Re: Cliff Island Septic, Wharf Rd

Letter of Transmittal

RE: COMMUNITY SEPTIC SYSTEM
CLIFF ISLAND COMMUNITY SEPTIC SYSTEM ASSOCIATION

The Division of Environmental Health has completed a review of a design for an engineered subsurface sewage disposal system design, to serve Cliff Island Septic System Association. The HHE-200 Form dated 09/27/12 was prepared by Mark Hampton, S.E. The system was designed by Pinkham & Greer Consulting Engineers, with plans signed and stamped by you. The application was complete for processing on 08/08/13.

DISPOSAL BEDS #1 & #2 PLAN
SCALE: 1"=20'

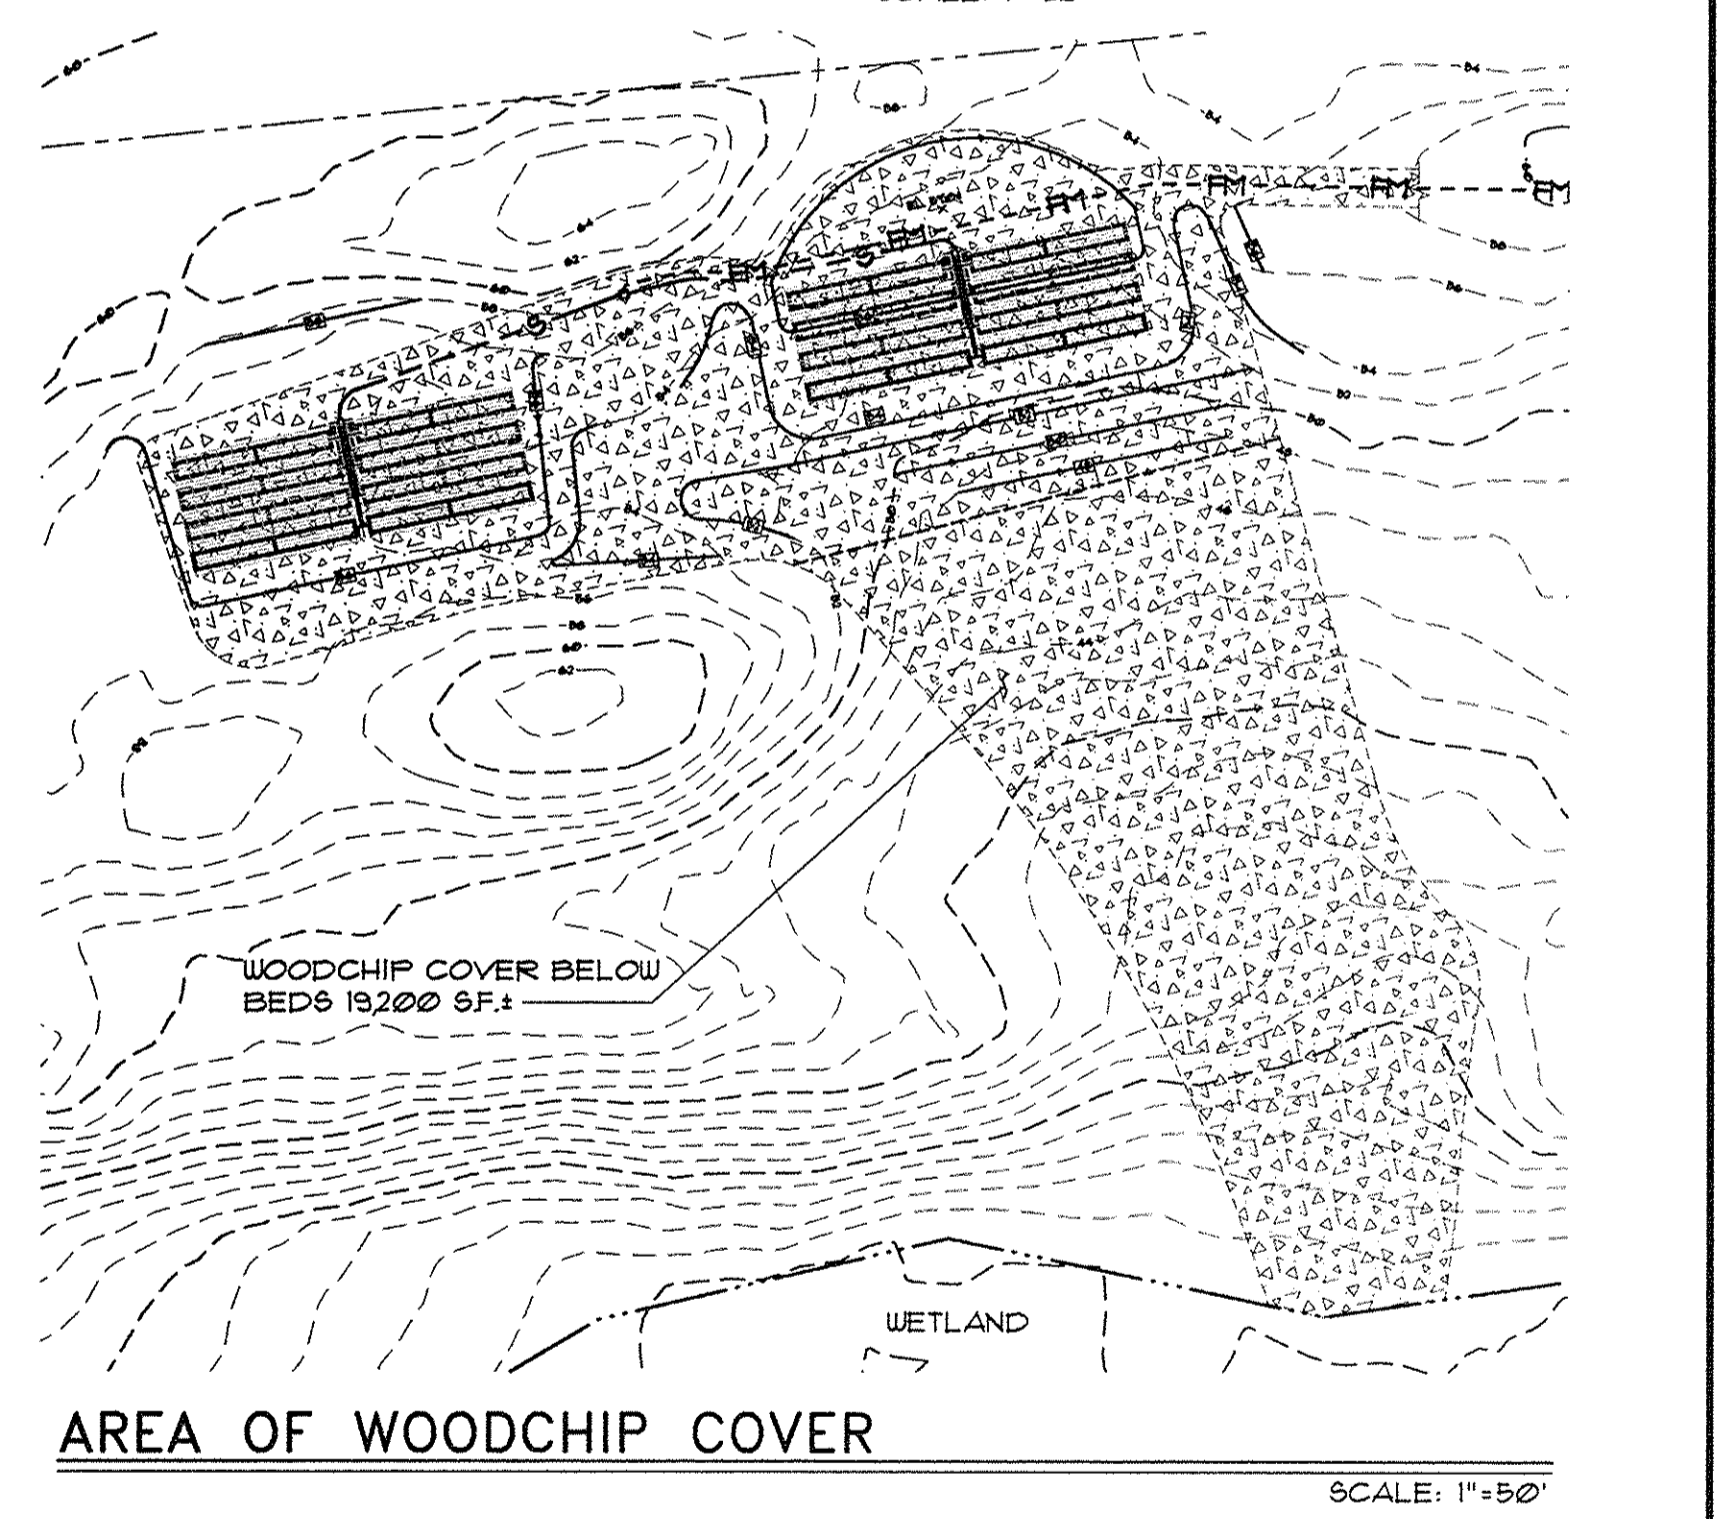
MDEP commented that no bedrock depth/elevation data was found to verify there will be a 2.96-foot bedrock/disposal field bottom separation distance as recommended by the mounding analysis. Soil data from two test pits was provided, but locations of the pits are not identified in the plans - additional observation holes appear to be warranted at the uphill edge of the proposed disposal fields to determine bedrock depth/elevation. Due to results of the transmissivity analysis, it is critical to insure this separation distance is maintained to minimize potential of a down gradient effluent breakout.

1. Prior to issuance of a permit to install the system, the design engineer must amend the site plan(s) to show that test pits are located within the disposal areas, and amend the O&M Manual to include periodic inspection and maintenance of the woodchip cover. Copies of these amended documents must be provided to the LPI and

REV.	DATE	DESCRIPTION
4	9/23/13	ADDED TEST PITS BY MARK HAMPTON
3	6/25/13	RELOCATED FORCEMAIN
2	4/9/13	ADDED WOODCHIP COVER AREA
1	3/26/13	REVISED FORCEMAIN LOCATION
